Waikato District Council
Attention: Milan Covic
Milan.Covic@waidc.govt.nz

17_147

68-72 GREAT SOUTH ROAD, POKENO – TRANSPORT PEER REVIEW ADDENDUM

Figure 24: Swept Path of Quad-Axle Semi-Trailer Tanker Left Turn Exit (from TIA Figure 5)

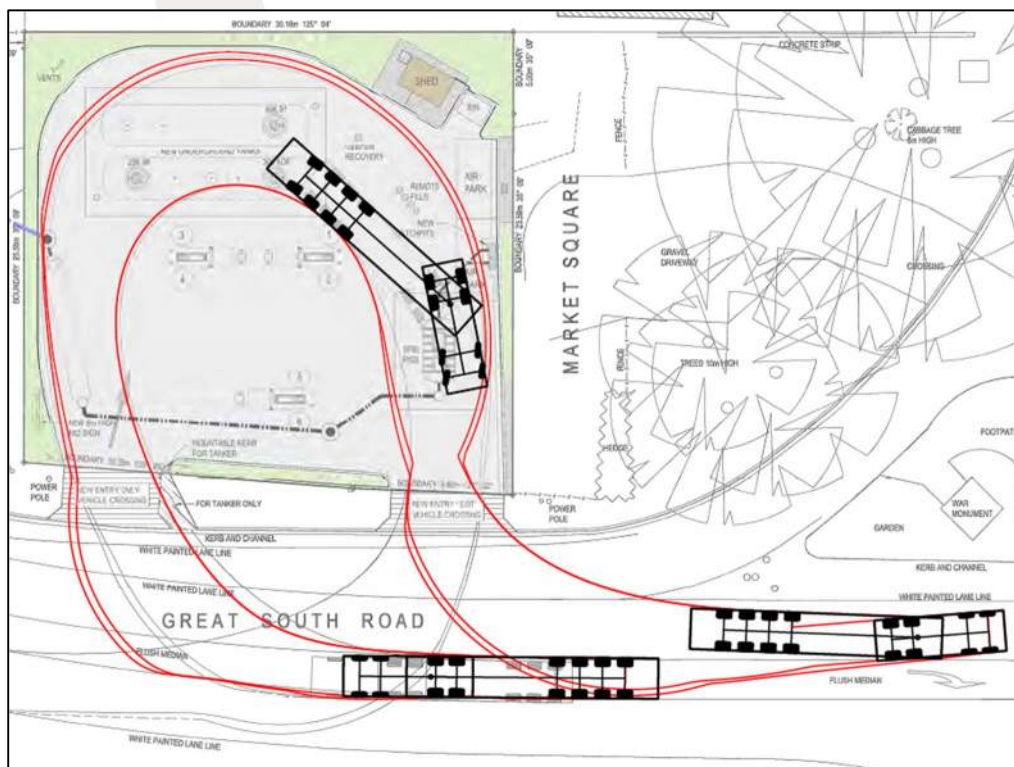
The tanker can turn left to exit the site (as shown in Figure 24) if the flush median space is used. This is acceptable for periods of low traffic flow on Great South Road, but less desirable during peak traffic periods. Turning right to exit the site may be difficult during peak traffic periods and may rely on the courtesy of approaching drivers to allow the tanker to turn onto Great South Road. Clear sight distance to the north is required to minimise the safety risk for drivers.

An option to mitigate turning effect may be to specify right turn entry and right turn exit only for fuel delivery tankers. It is preferable that a tanker arriving from the north can loop around the village and approach the site from the south. Similarly, a tanker departing towards the south should be able to turn right from the site and loop around the village to head south. Consideration needs to be given to the potential effects of tankers circulating around the village to meet the entry and exit restrictions.

Figure 25: Suggested Heavy Vehicle Circulation Route

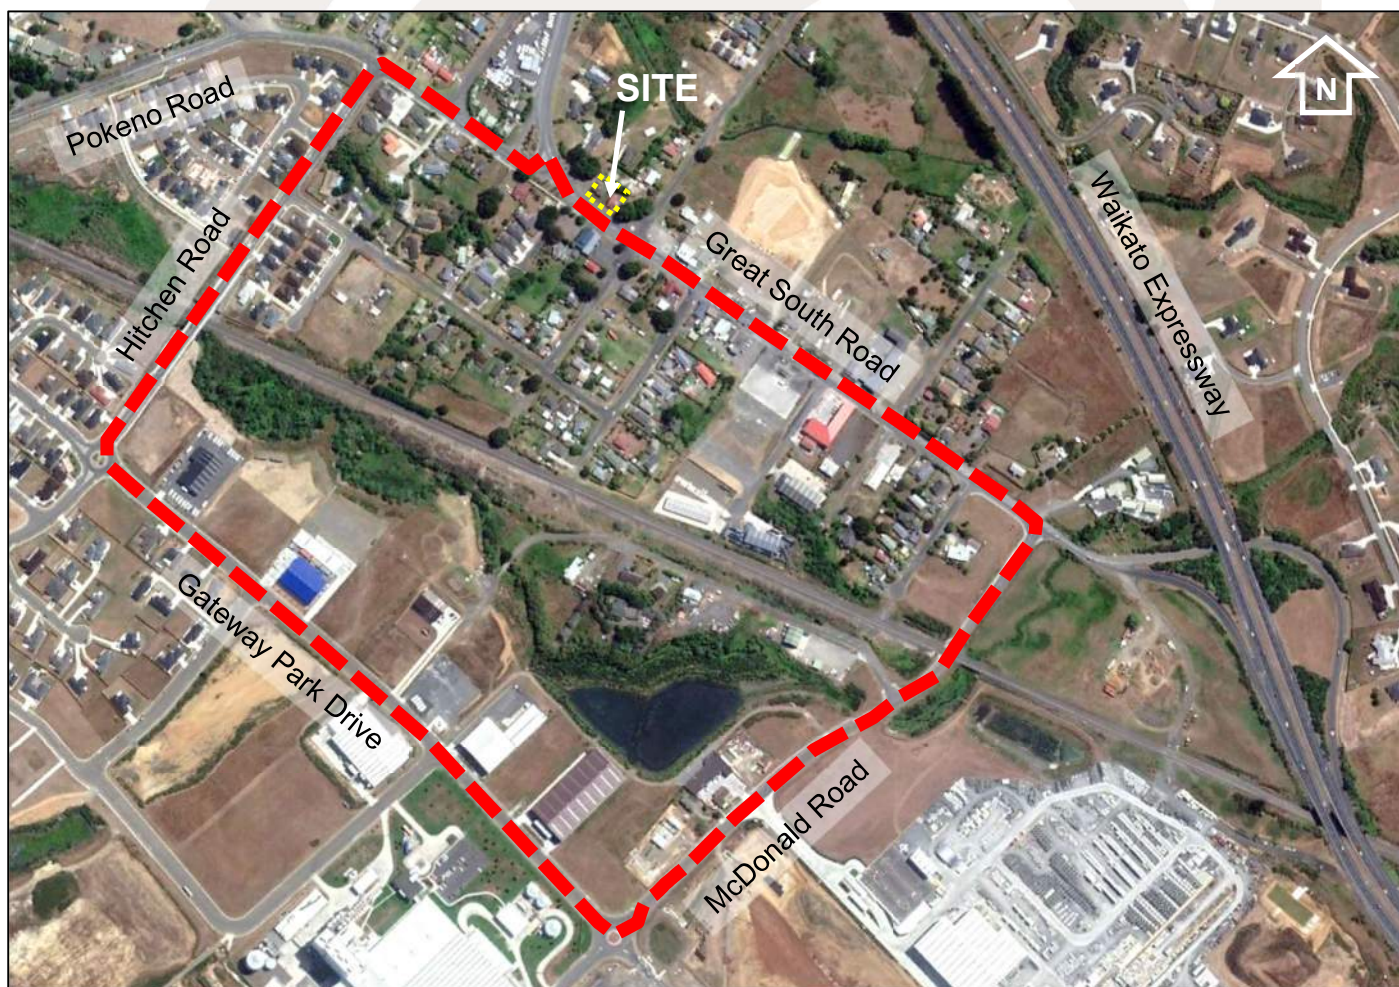
We recommend that the Applicant consult with Waikato District Council to identify a preferred heavy vehicle route for tankers to circulate on that allows them to approach the site from the south and depart to the north, or south. We suggest using the industrial streets as shown in the figure below. These streets and intersections are designed for long and large vehicles, making this a suitable heavy traffic route which avoids residential streets.

Identifying a preferred heavy vehicle circulation route such as shown in Figure 25 (Great South Road, Pokeno Road, Hitchen Road, Gateway Park Drive, McDonald Road), provides a way to manage effects of large vehicles driving along residential streets.
